# UNITED STATES PATENT AND TRADEMARK OFFICE

APPLICATION NO.	FILING DATE	FIRST NAMED INVENTOR	ATTORNEY DOCKET NO.	CONFIRMATION NO.
10/791,883	03/04/2004	Ming Tang Huang	MR2349-993	4802
4586	7590	03/10/2006	EXAMINER	
ROSENBERG, KLEIN & LEE 3458 ELLICOTT CENTER DRIVE-SUITE 101 ELLICOTT CITY, MD 21043			PAPE, ZACHARY	
			ART UNIT	PAPER NUMBER
			2835

<b>Office Action Summary</b>	<b>Application No.</b> 10/791,883	<b>Applicant(s)</b> HUANG, MING TANG	
	<b>Examiner</b> Zachary M. Pape	<b>Art Unit</b> 2835

## DETAILED ACTION

Fig 1

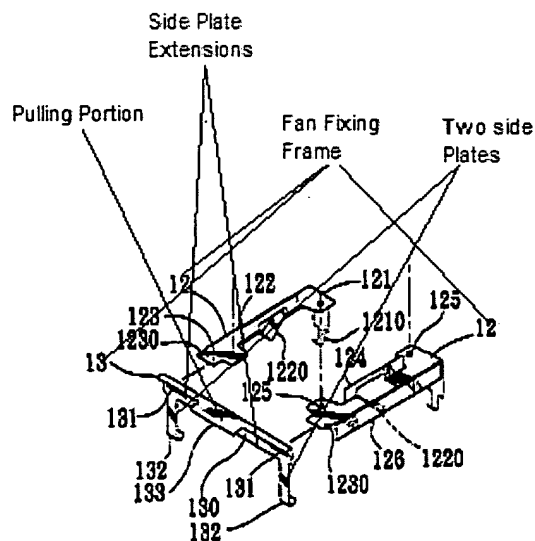
With respect to claim 1, Lai teaches a heat dissipation module for a CPU, suitable for installation above the CPU and base socket, comprising: a heat dissipation device (20), having a plurality of heat dissipation fins, flowing paths being formed between the fins; a fan fixing frame (Comprising 12 and 13), fixed above the heat dissipation device, the fan fixing frame having a top plate (As illustrated in present office action Fig 1 below), two side plates (As illustrated in present office action Fig 1 below), a plurality of the elastic pressing components (1220) and at least one positioning elastic strip (126), the two side plates extending from opposite sides of the top plate, the two

side plates extending (Toward each other) to form a pulling portion (133) and (Toward the CPU) to form a plurality of clipping portions (132), the elastic pressing components being installed on the top plate, the positioning elastic strip being installed on the top plate, and the positioning elastic strip forming at least two pushing portions (123) to touch an outer surface of the two side plates (As illustrated in Lai Fig 3); and a fan (110) fixed on the top plate of the fan fixing frame; wherein the fan fixing frame is installed above the base socket by using the clipping portions (132) to connect with related clipping arms (41) on the two sides of the base socket, the elastic pressing components having the elastic force to press the heat dissipation device onto the heat exhausting surface of the CPU (Column 4, Lines 37-40).

With respect to claim 5, Lai further teaches that the pulling portion of the fan fixing frame is formed by outer extension of the two side plates, the pulling portion having a free and upper end, the clipping portion being formed by downward extension of the two side plates (As illustrated in Lai figure 2, and Present office action Fig 1 above).

Fig 2

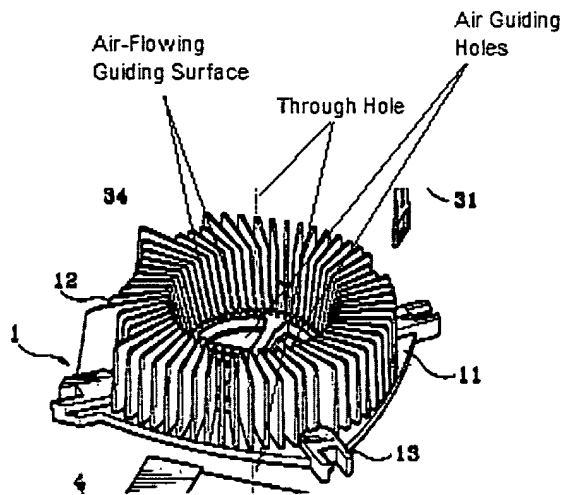
With respect to claim 2, Lai teaches the limitations of claim 1 above, but fails to teach the limitations of claim 2. Liu teaches a heat dissipation device with a through hole with a shape feature of penetrating the heat dissipation device from top to bottom, flowing paths (Between each Fin, 12) having connection paths through the bottom, top and outer side of the heat dissipation device, a side wall of the through hole having an air-flowing guiding surface (As defined by the fin area defining the through hole) at a top area and a plurality of air guiding holes at a bottom area, the air guiding holes

connecting with the flowing paths (See present office action Fig 2 for more detailed annotations). It would have been obvious to one of ordinary skill in the art at the time the invention was made to combine the teachings of Liu with that of Lai to efficiently carry heat away from the heat sink module (Liu Column 2, Lines 49-50).

Fig 3

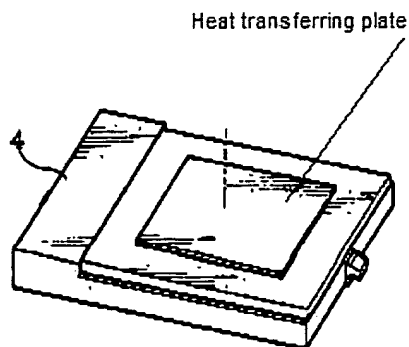
With respect to claim 3, Liu further teaches a heat transferring plate installed in a bottom position to face the through hole of the heat dissipation device and contact the heat exhausting surface of the CPU (See present office action Fig 3 below).
